Sumter City-County Planning Commission

October 23, 2024

MSP-24-57/HCPD-24-38 – 380 General Dr. – Patriot Park Miracle Field and Playground (City)

Figure 3 - Proposed Site Landscaping Plan

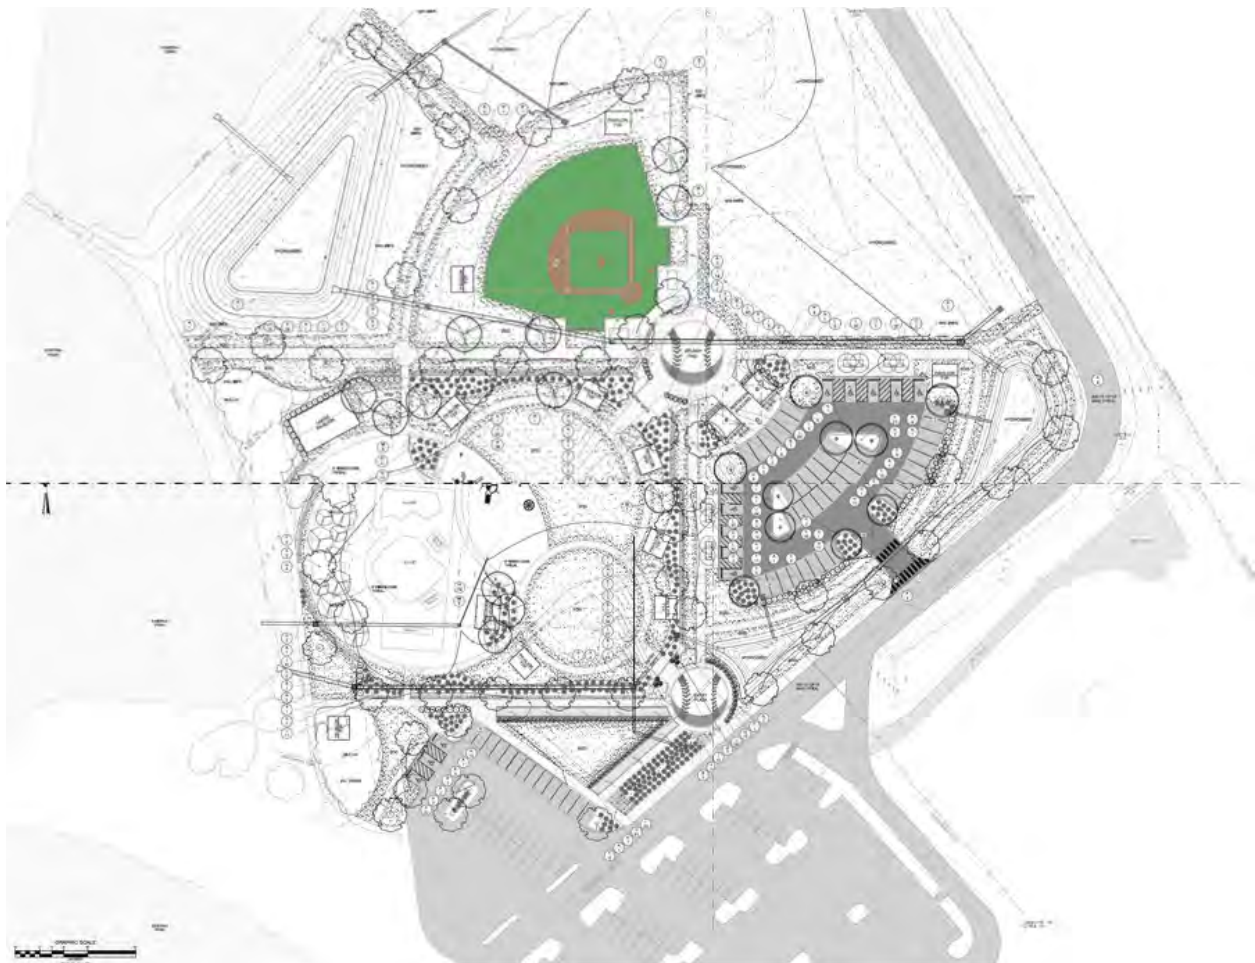
The submitted landscape plan is based upon the requirements of *Article 9*. Landscape buffers along the perimeter of the property, and landscaping within the site, meet or exceed the minimum standards as shown on the submitted plans.

The proposed project will involve the removal of +/- 39 pine trees larger than 18 inches dBH, and 2 gum trees larger than 18 inches dBh, as well as other smaller trees not classified as 'significant' or 'historic' based on size. The planting plan for the facility includes 81 new canopy trees (50 *Laurel Oak*, 12 *Chinese Elm*, 10 *Willow Oak*, and 9 *Longleaf Pine*), as well as 30 *Sabal Palm* and 8 *Natchez Crepe Myrtle* understory trees.

Staff's evaluation is that the landscaping requirements outlined in *Article 9* have been met and/or exceeded by the proposed landscape plan.

Figure 5 - Building #1 Elevations

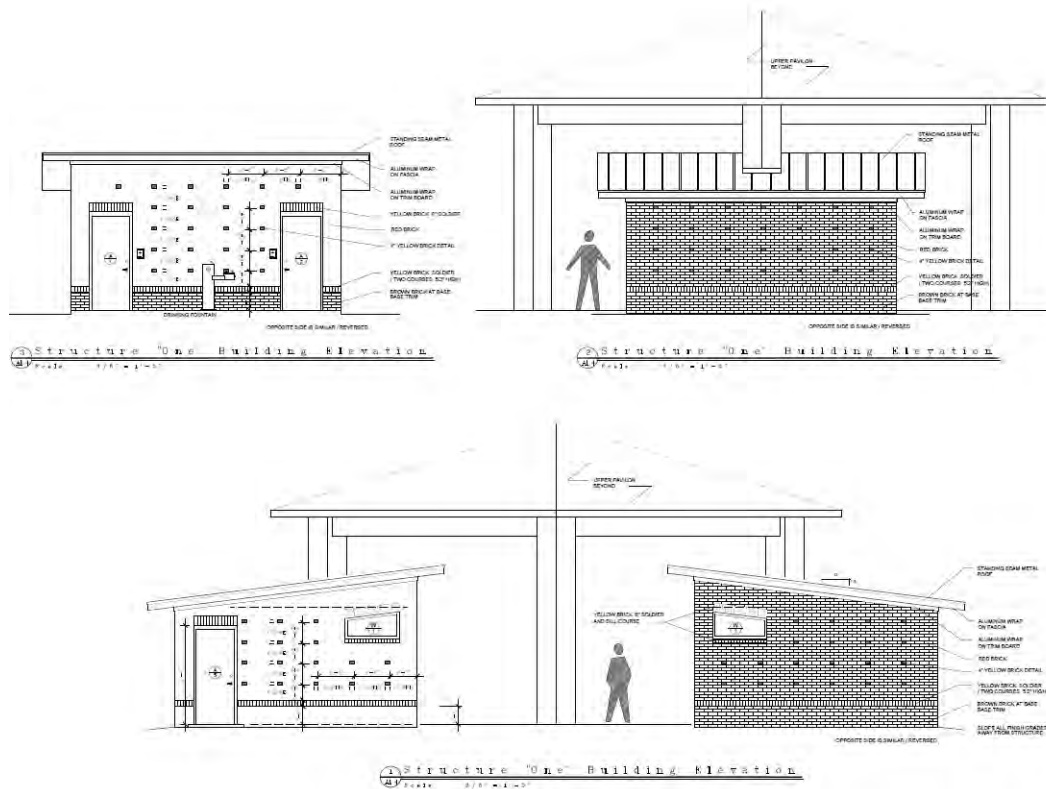
Staff Review: Based on supplied renderings, the proposed structure does not exceed the 60% threshold.

Figure 6 - Building #2 Elevations

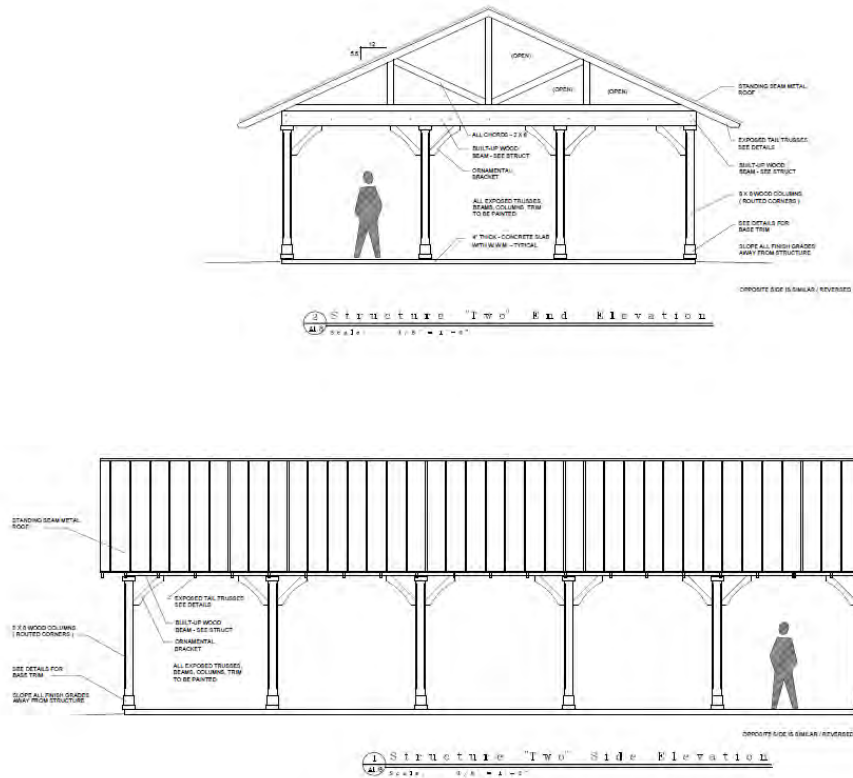
Staff Review: The proposed exterior materials are a combination of various types of brick, which is consistent with the brick, stucco, or stone masonry requirement in the HCPD.

The roof is proposed to be pitched standing seam metal. The proposed roof pitch is considered to be complementary and compatible with construction of similar type.

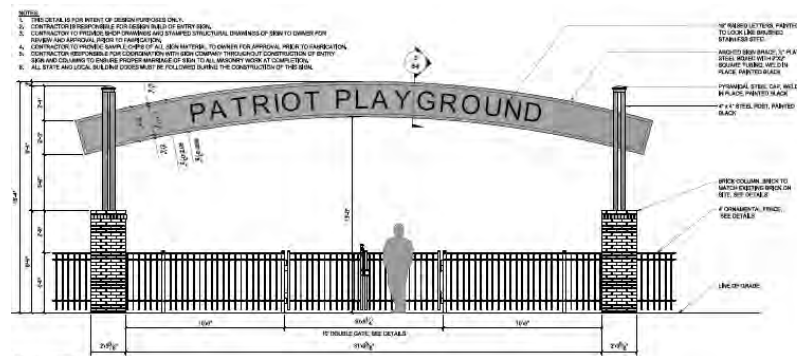
Staff Review: Exterior signage must comply with *Article 8.h.* of the Ordinance. The submitted plans include one proposed sign shown below, which meets the HCPD standard.
